SERVICE TECHNICAL INFORMATION

UTSUNOMIYA, APR. 15, 1999
 REF. NO.: SI-98-050
 CUSTOMER RELATIONS & SERVICE DIV.

MODEL : XR-MD85

SUBJECT : Inability to play CD

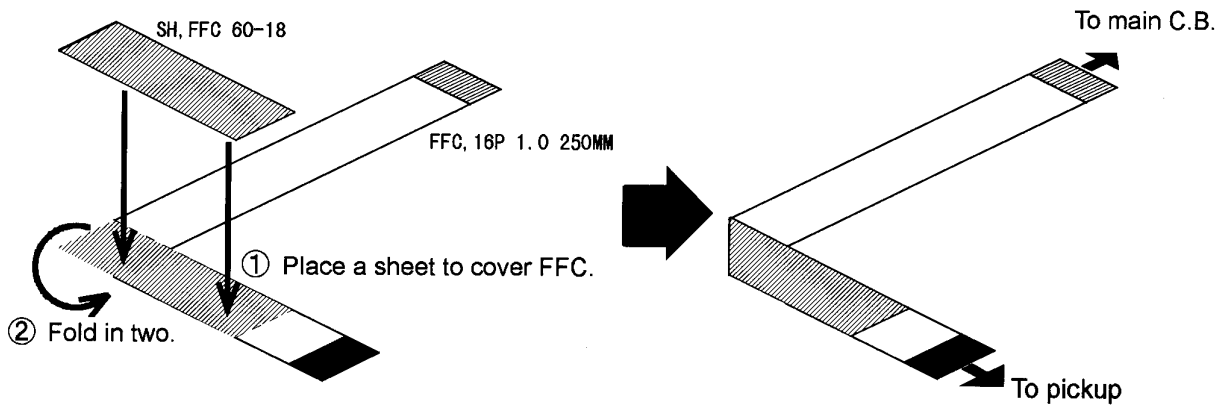
CONTENTS : Coating on the 16-P FFC between the pickup and the CD C.B. may come off, by rubbing against the cabinet bottom. Worn-out coating may cause a break in R70, which results in inability to play CD. Take the action described below, regardless of the troubles currently occurring.

ACTION : Place a sheet on 16-P FFC as shown in the figure.
